INFORMATION REQUEST

APPLICATION NO: MCUI/41/2024
PROPERTY ADDRESS: 35A AND 35B NORTH ROAD AND ALBERT PARK, 16 HAGUE STREET, WOODRIDGE QLD 4114
PROPERTY DESCRIPTION: LOT 3 RP 126257, LOT 4 RP 126257, LOT 62 RP 111108
APPLICATION DESCRIPTION: MATERIAL CHANGE OF USE - COMMUNITY CARE CENTRE

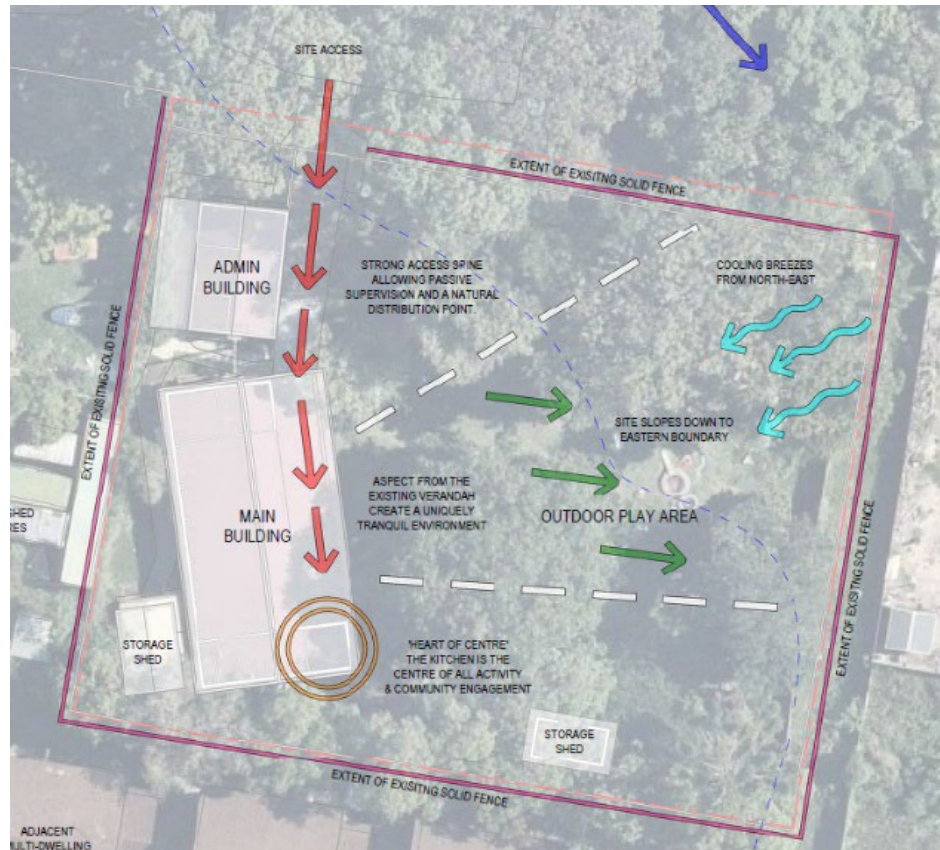
- 1.1. Provide amended Plans of Development which notate and dimension the required access easement over Lot 62 on RP 111108 facilitating access to Lot 3 and Lot 4 on RP 126257.

Advice Note: Access and parking for the use is proposed to be achieved through existing facilities on the northern adjoining Albert Park. Details regarding the proposed access are required to define the full extent of any potential access easement, which will need to cater for vehicular and pedestrian movement through Albert Park to the proposed development site. Furthermore, a license will likely be required for the use of parking facilities within Albert Park by the proposed development, potentially stipulating parameters for the use, including specific parking spaces and hours of operation. Additional details will be provided following further internal discussions regarding these arrangements with the custodian (Council's Parks team) and Council's Corporate Property team and a meeting can also be arranged to discuss the required management strategies. It should also be noted further amendments to the proposal may be requested upon receipt of additional information, subject to further discussions regarding parking availability, etc.
